RAI 02.04.04-9, Supplement 1, Part A:

The following changes will be made to COLA, Part 2, Tier 1, Section 5.0, Tier 2 Subsections 2.0, 2.4S.1, 2.4S.2, 2.4S.4, 2.4S.6, 2.4S.10, 2.4S.14, 2.5S.5, 3.4, and 3H, and COLA Part 7, Subsection 2.1, to incorporate the revised main cooling reservoir (MCR) embankment breach analysis as described in the responses to RAI questions 02.04.04-9 and 02.04.04-10.

Supplement 1, Part B, to RAI 02.04.04-9 Response:

Figure 2.4S.4-13: Outflow Rates Experienced from Breached Dams (Reference 2.4S.4-12e)

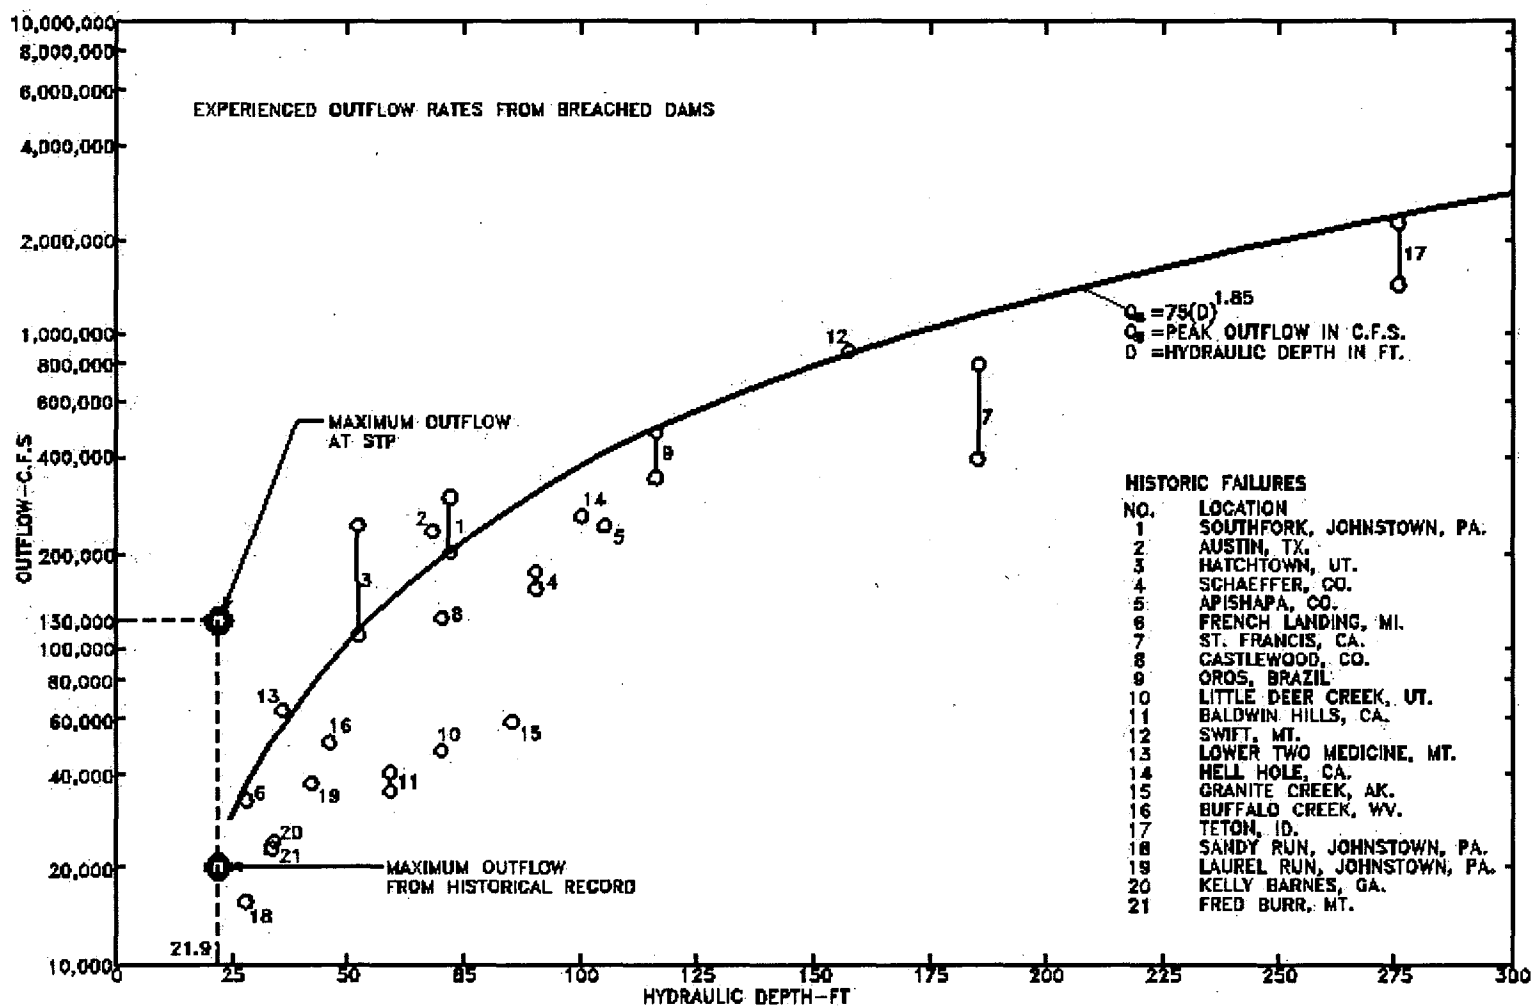
COLA Tier 2 Figure 2.4S.4-13 is deleted in its entirety and replaced with the following:

Figure 2.4S.4-14: Units 3 and 4 Site Grading Plan

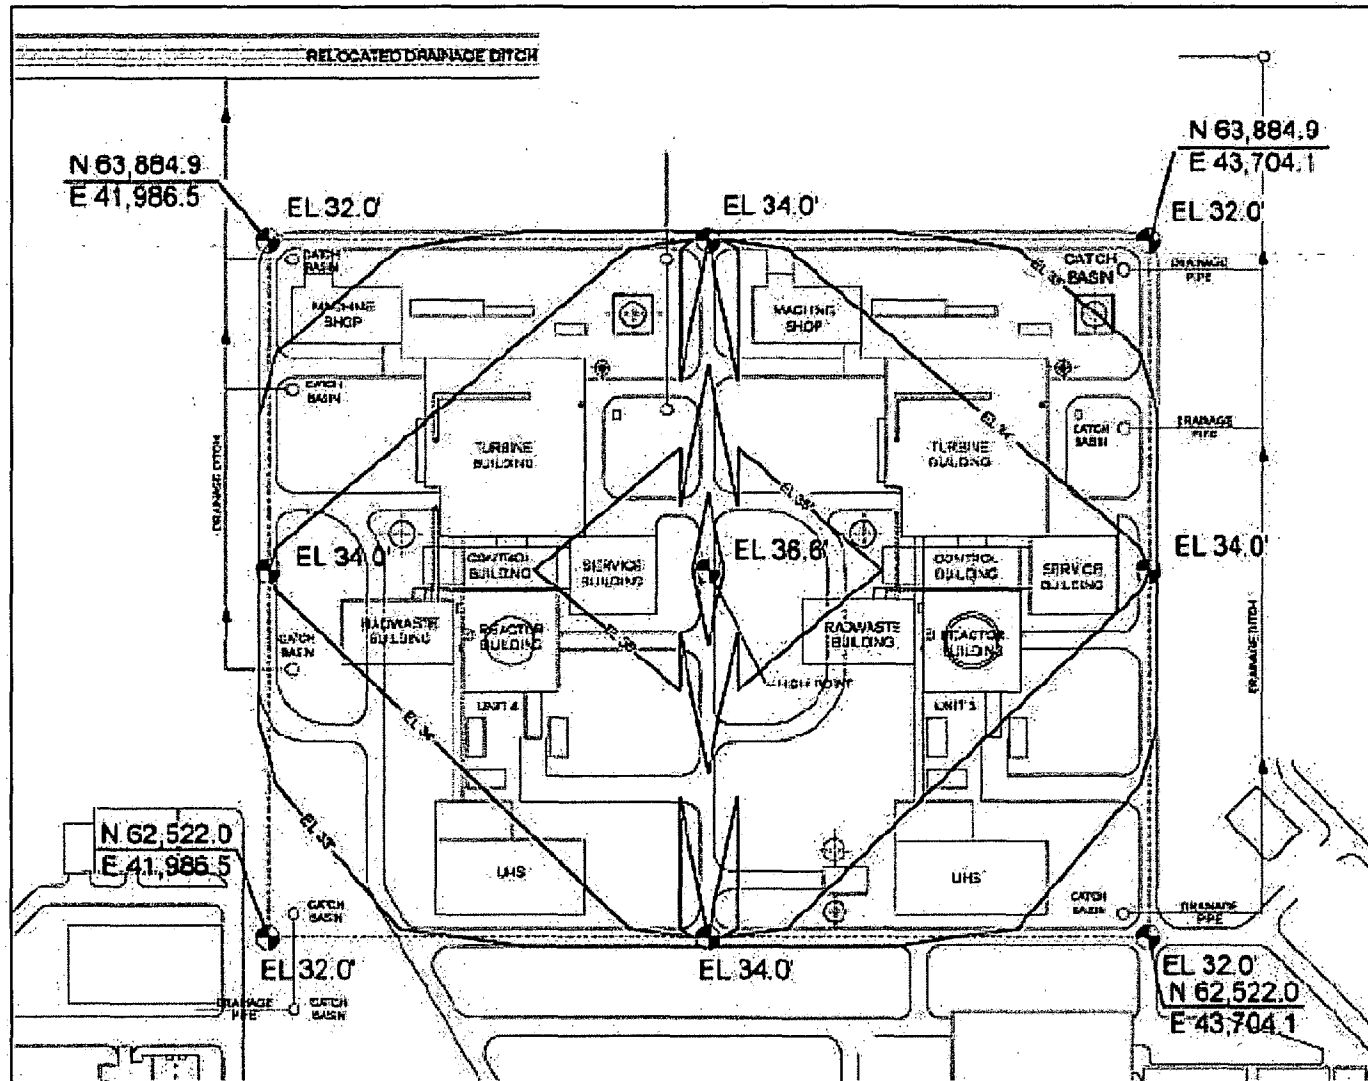
COLA Tier 2 Figure 2.4S.4-14 is deleted in its entirety and replaced with the following:

Figure 2.4S.4-15: STP Site Layout

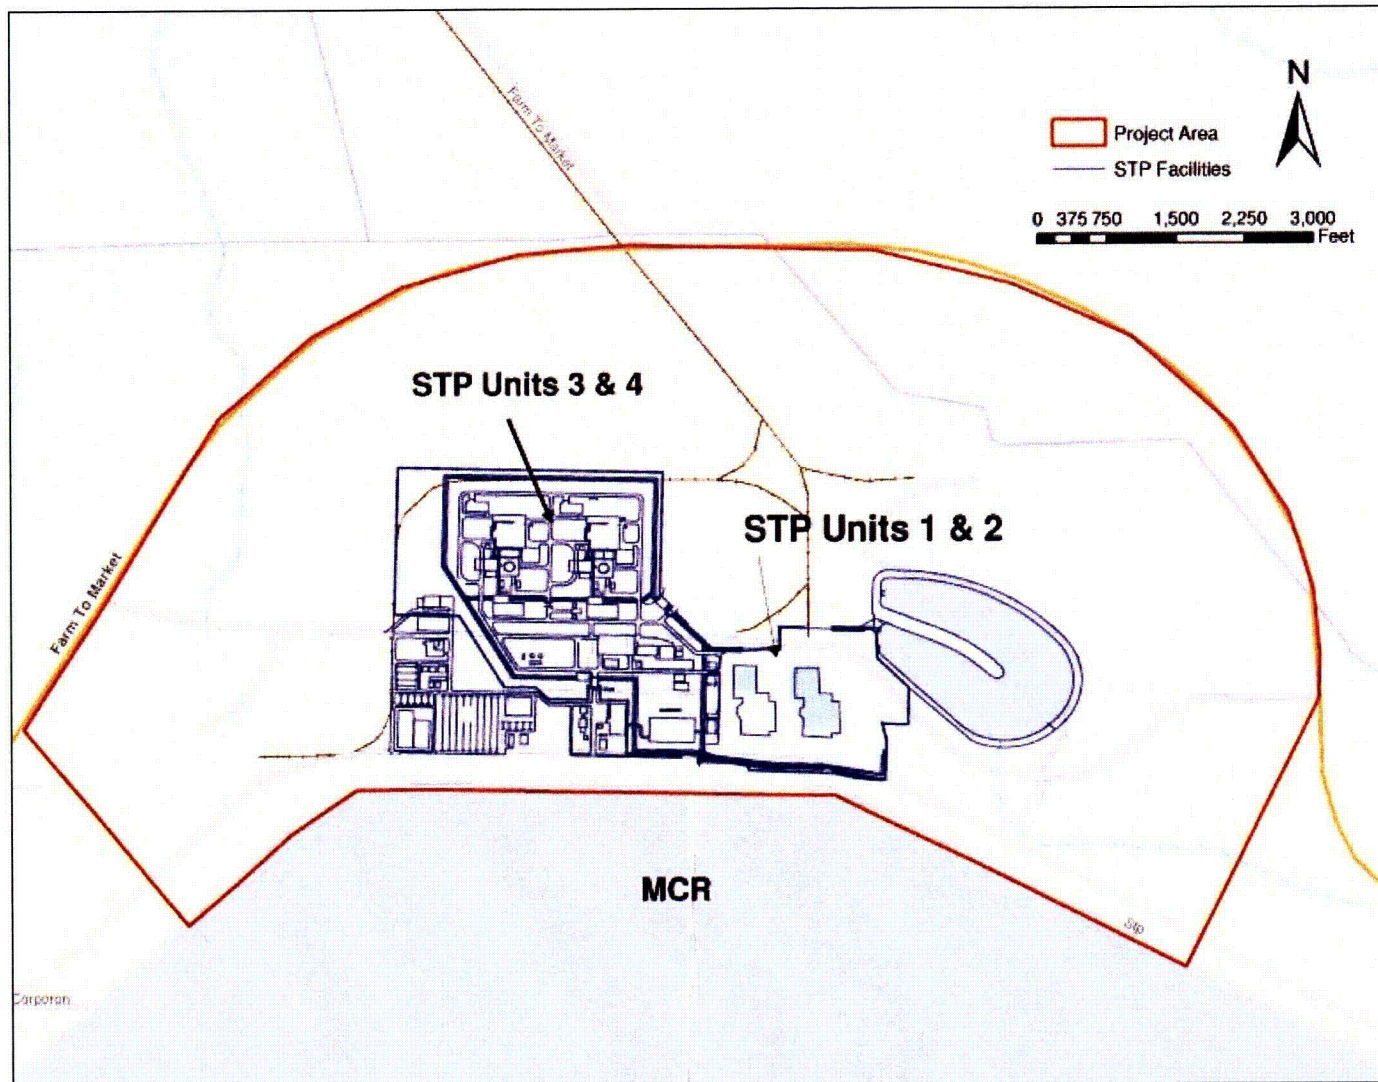
The buildings of STP Units 1 & 2 and STP 3 & 4 shown in Figure 2.4S.4-15 were represented in the Delft3D-FLOW model. In addition the Units 1 & 2 ECP and MCR embankment were represented in the model. All these features were modeled as "dry points" in which the flows perpendicular to the four faces of the grid cells, representing the buildings and the embankments, are blocked. Table 2.4S.4-6 depicts the buildings for which the "dry points" option was invoked. In addition, Figures 2.4S.4-15 and 2.4S.4-16 show the modeled and the physical locations of the building outlines, represented by black and blue lines, respectively.

COLA Tier 2 Figure 2.4S.4-15 is deleted in its entirety and replaced with the following:

Figure 2.4S.4-16: Two-Dimensional View of Developed 2-D Grid with an East Breach

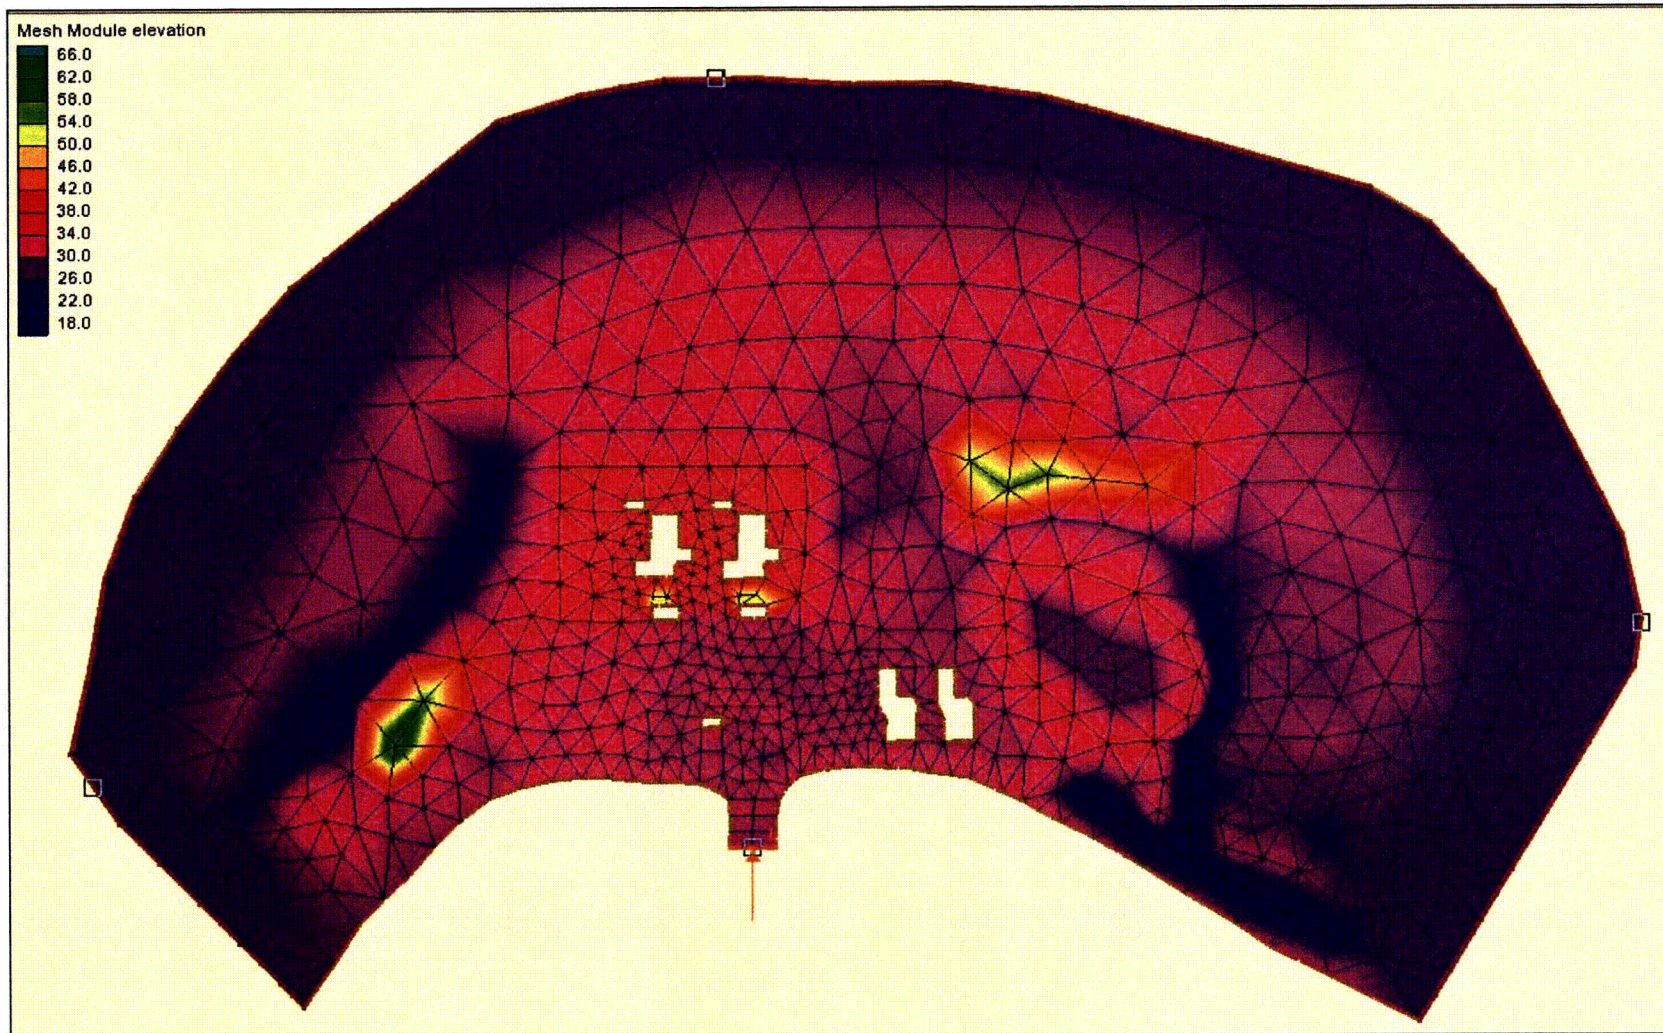
COLA Tier 2 Figure 2.4S.4-16 is deleted in its entirety and replaced with the following:

Figure 2.4S.4-17: Two-Dimensional View of Developed 2-D Grid with a West Breach

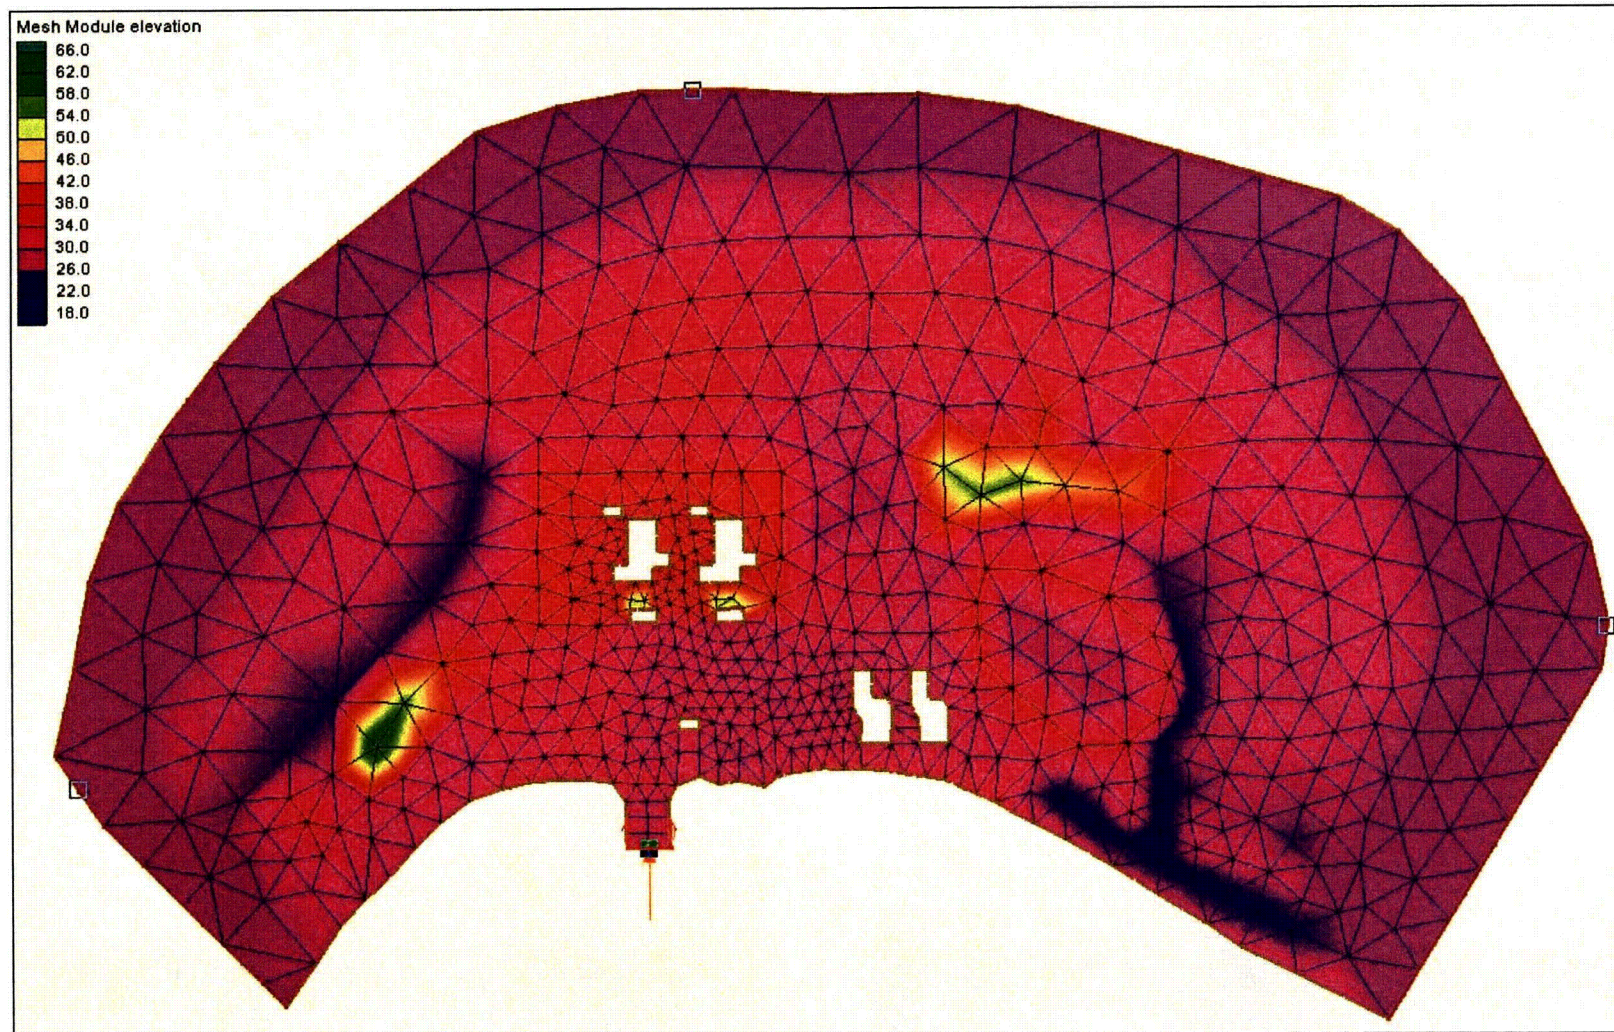
COLA Tier 2 Figure 2.4S.4-17 is deleted in its entirety and replaced with the following:

Figure 2.4S.4-18: Assigned Material Types of Developed 2-D Grid

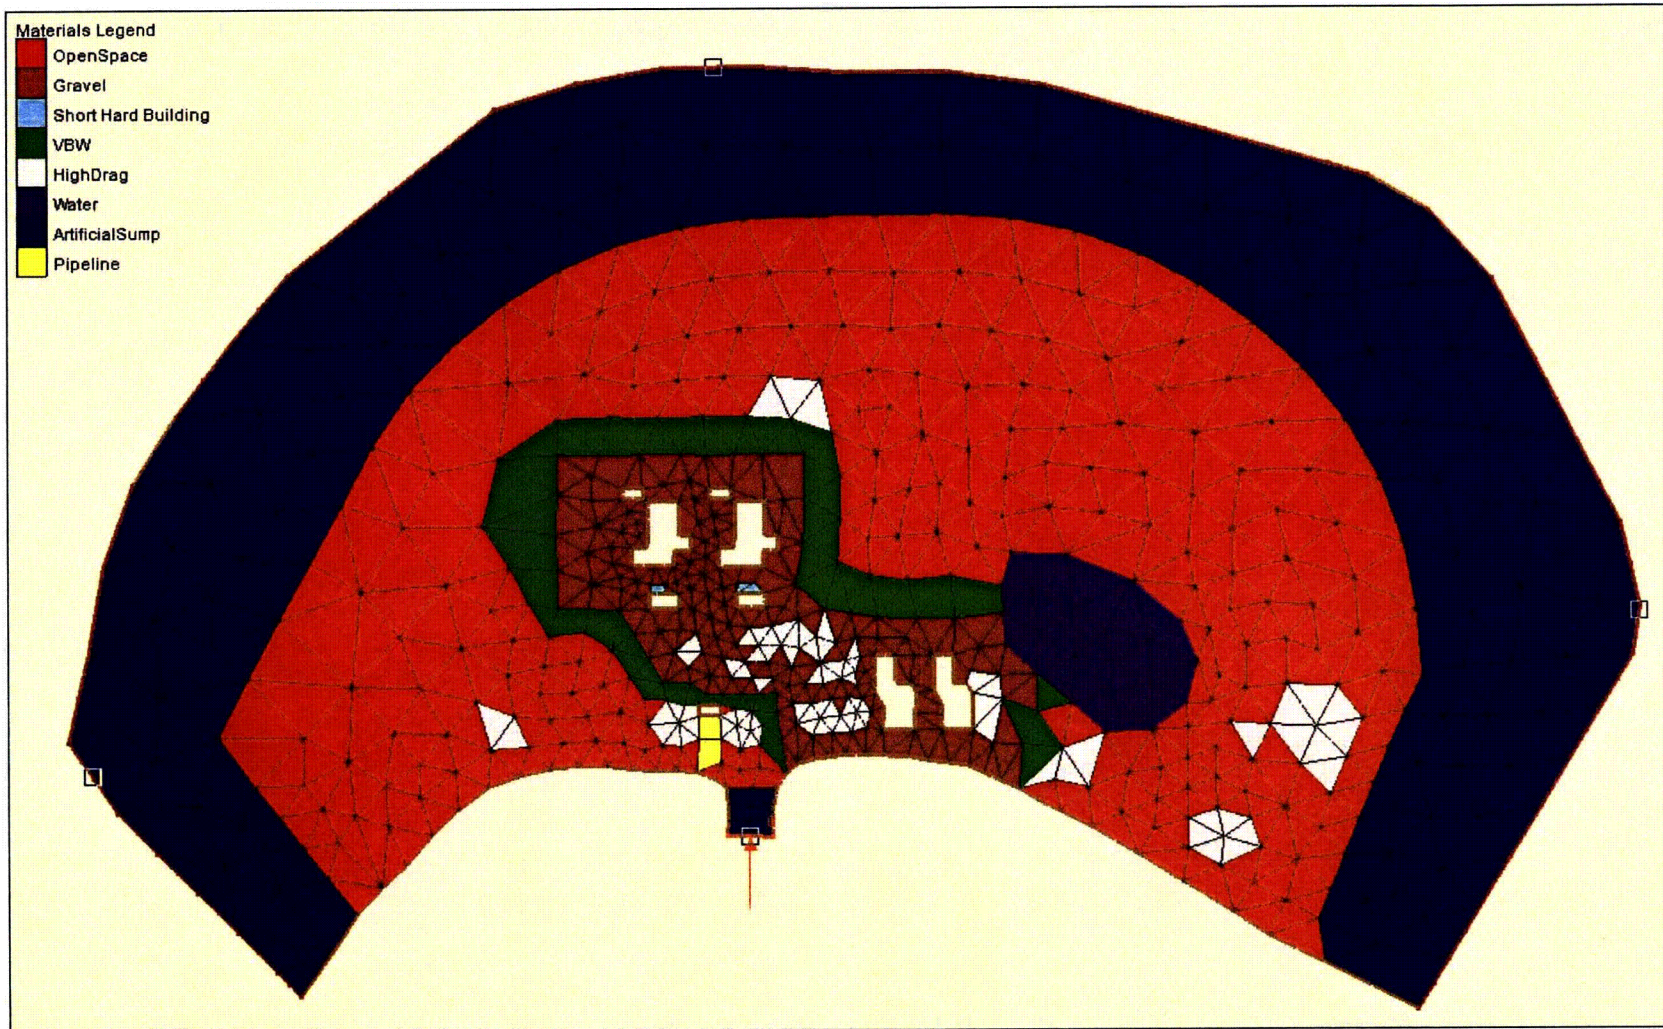
COLA Tier 2 Figure 2.4S.4-18 is deleted in its entirety and replaced with the following:
